NINE MILE POINT NUCLEAR STATION, UNIT NO. 1

AMENDMENT TO FACILITY OPERATING LICENSE

Amendment No. 26
License No. DPR-63

ATTACHMENT TO LICENSE AMENDMENT NO. 26

Figure 3.3.2 a
ALLOWABLE PRESSURE SUPPRESSION SYSTEM
4 FOOT DOWNCOMER SUBMERGENCE

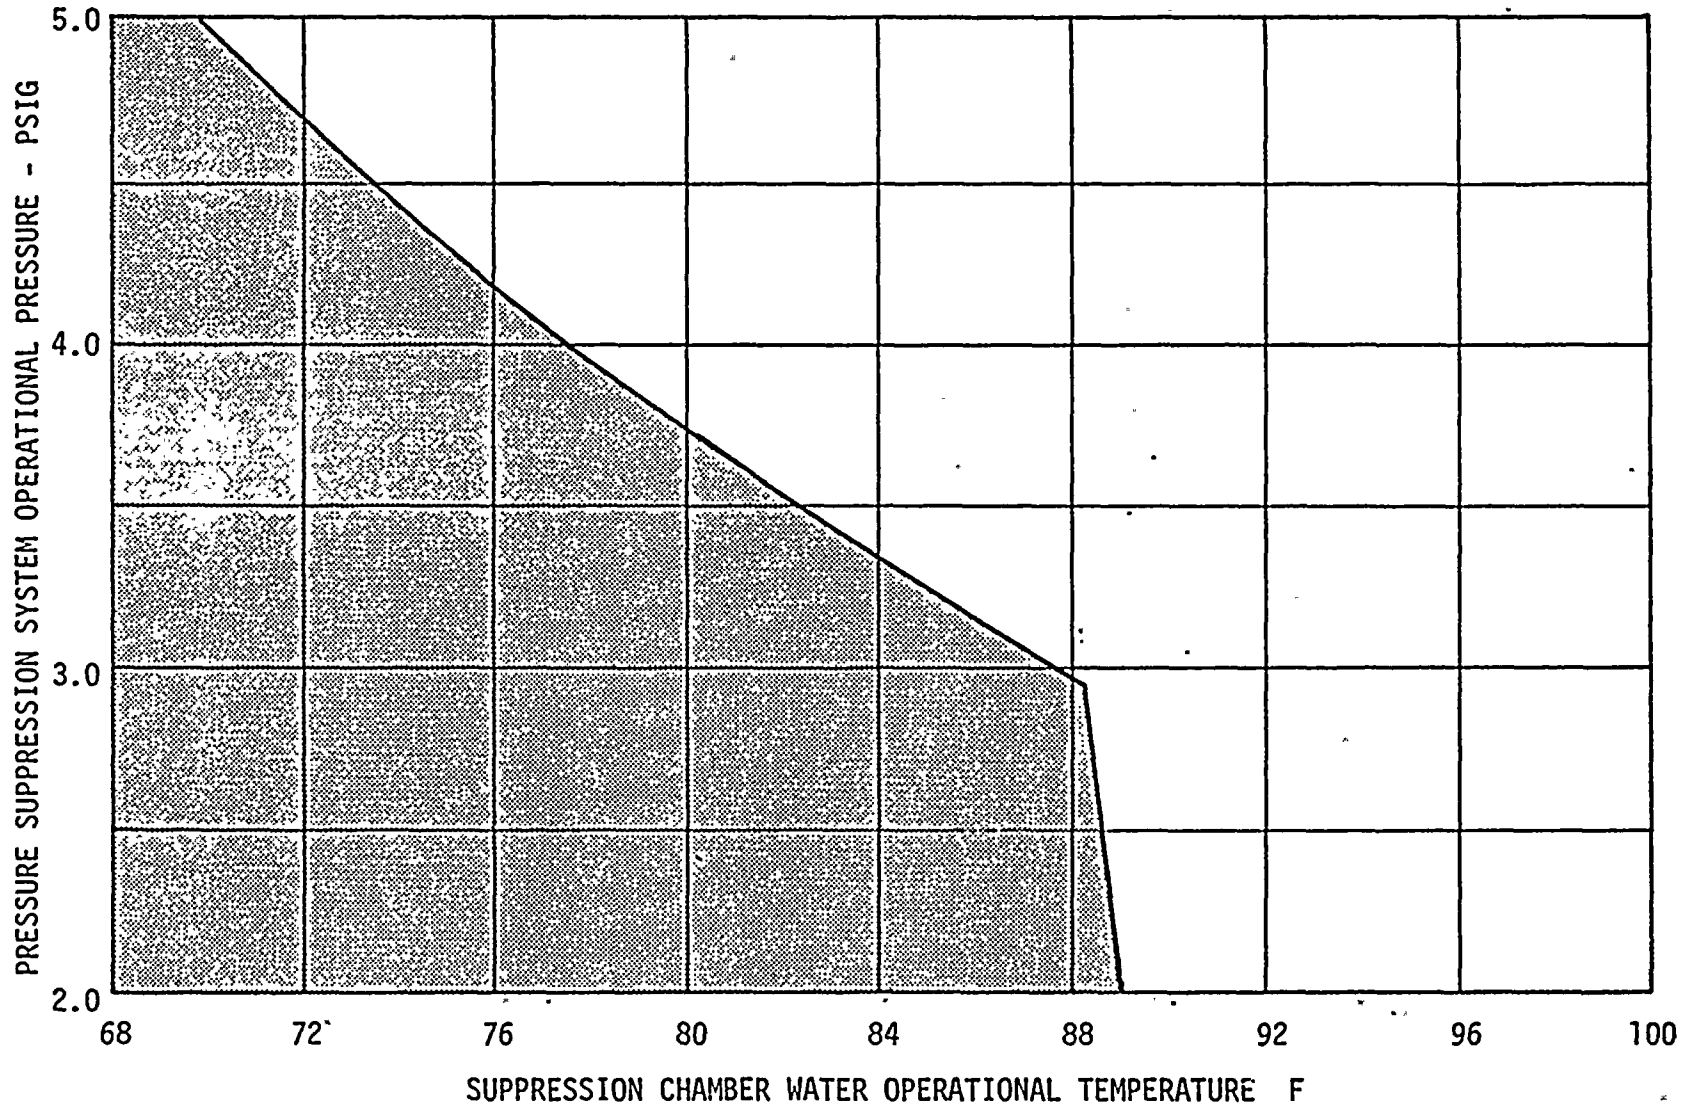
- (1) Figure 3.3.2a when downcomer submergence is ≥ 4 feet, or (2) Figure 3.3.2b when downcomer submergence is ≥ 3 feet. If these temperatures are exceeded, pool cooling shall be initiated immediately.

FIGURE 3.3.8

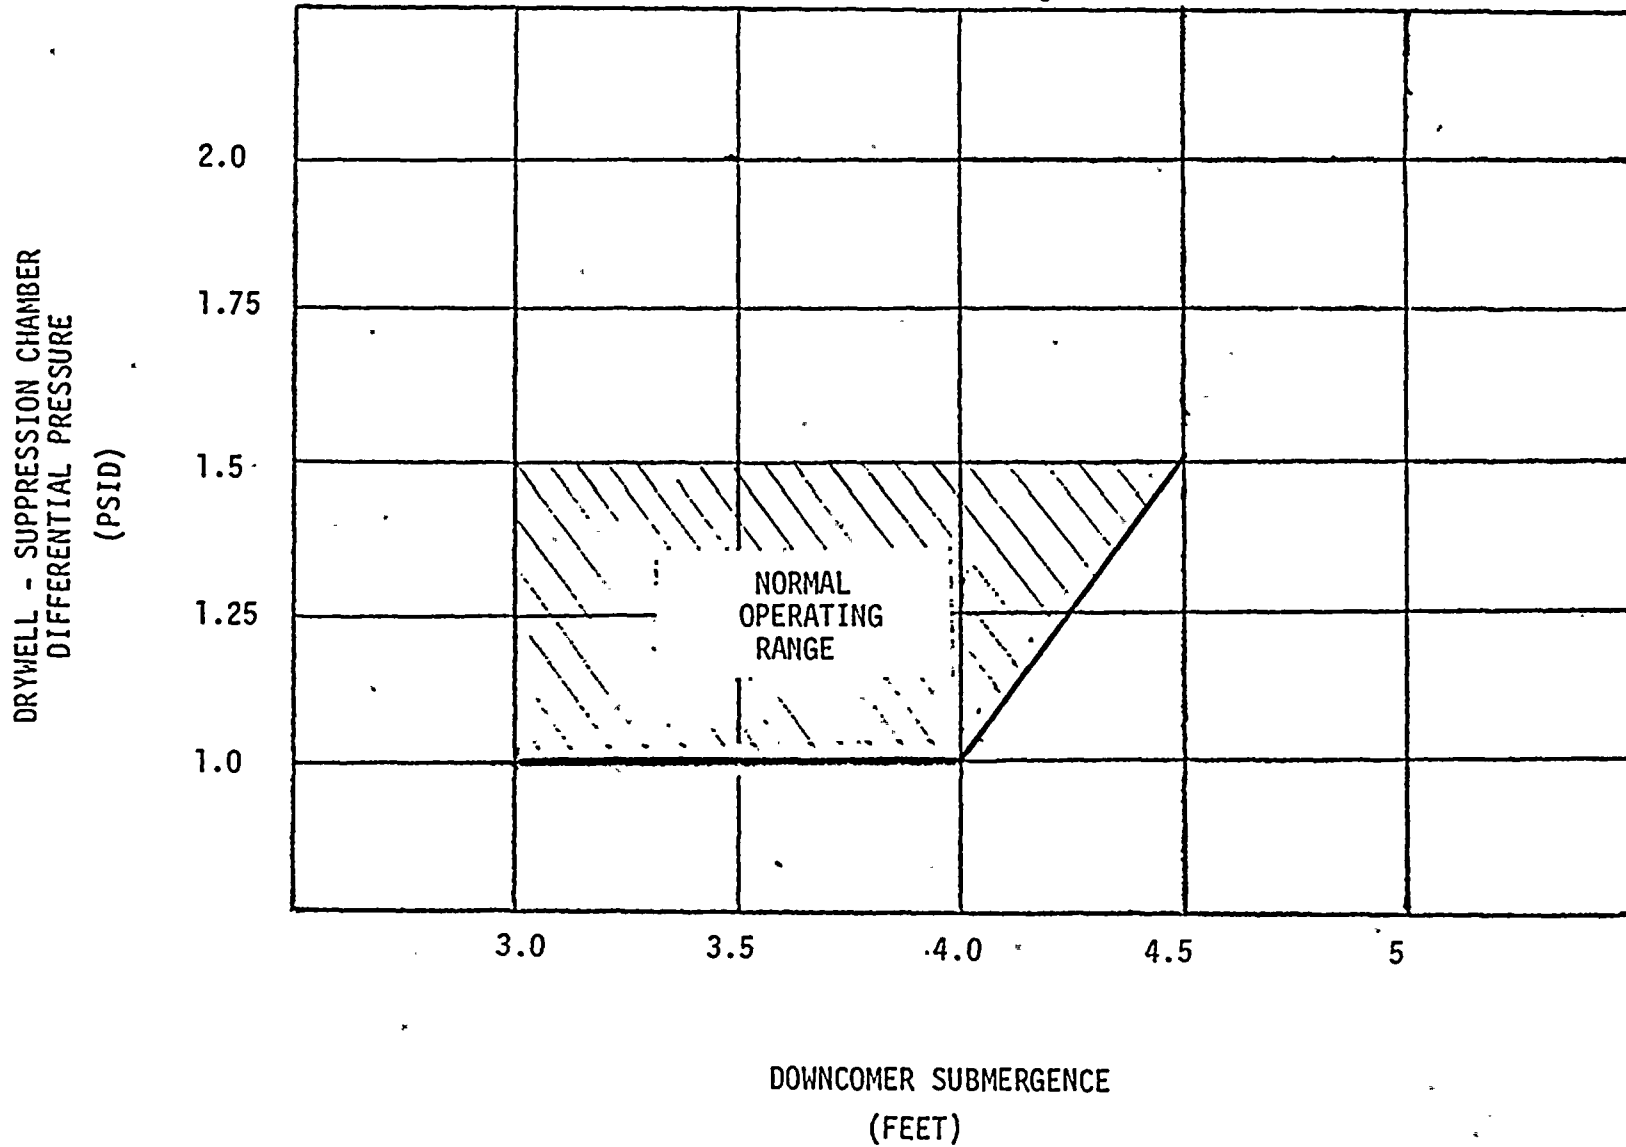
- a. Differential pressure between the drywell and suppression chamber shall be maintained at or above levels according to Figure 3.3.8 except as specified in (1) and (2) below:
 - (1) The differential pressure shall be established within 24 hours of achieving operating pressure and temperature. The differential pressure may be reduced to less than that specified by Figure 3.3.8 24 hours prior to a scheduled shutdown.
 - (2) This differential may be decreased to less than that of Figure 3.3.8 for a maximum of four (4) hours during required operability testing of the drywell-pressure suppression chamber vacuum breakers.

In conjunction with the Mark I Containment Short Term Program, a plant unique analysis was performed which demonstrated a factor of safety of at least two for the weakest element in the suppression chamber support system and attached piping. The maintenance of a drywell-suppression chamber differential pressure in accordance with Figure 3.3.8 and suppression chamber water level corresponding to a downcomer submergence range of 3.0 to 4.5 feet will assure the integrity of the suppression chamber when subjected to post-LOCA suppression pool hydrodynamic forces.
